Sent: 12/06/2025 10:23:15 PM
Subject: DA2025/0555 - 14 warekila rd, Beacon Hill
Attachments: objection.pdf;

Re: DA2025/0555 - Lot 7 Sec96 DP244645, 14 Warekila Rd, Beacon Hill

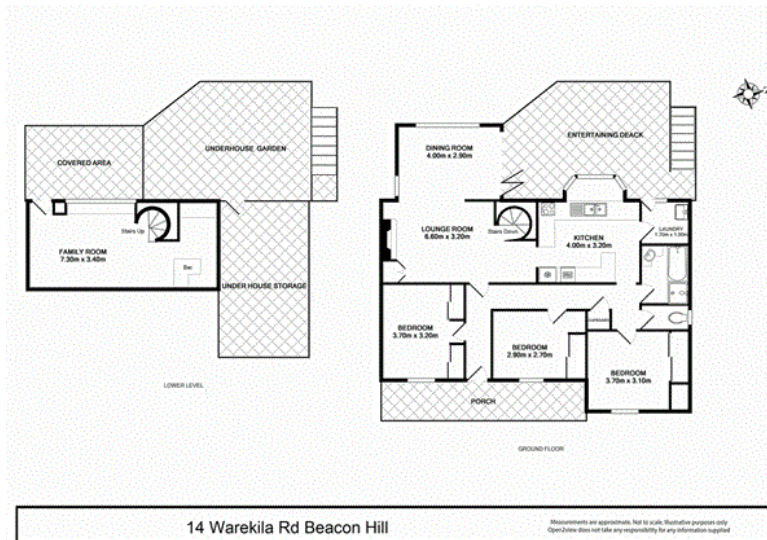
As you can see by the photo below, if you add another storey it will almost all, if not all, block the sun, and breeze from our home.

This photo is taken from our second storey and we are at similar heights at this level (this is their single storey at the front of the property).
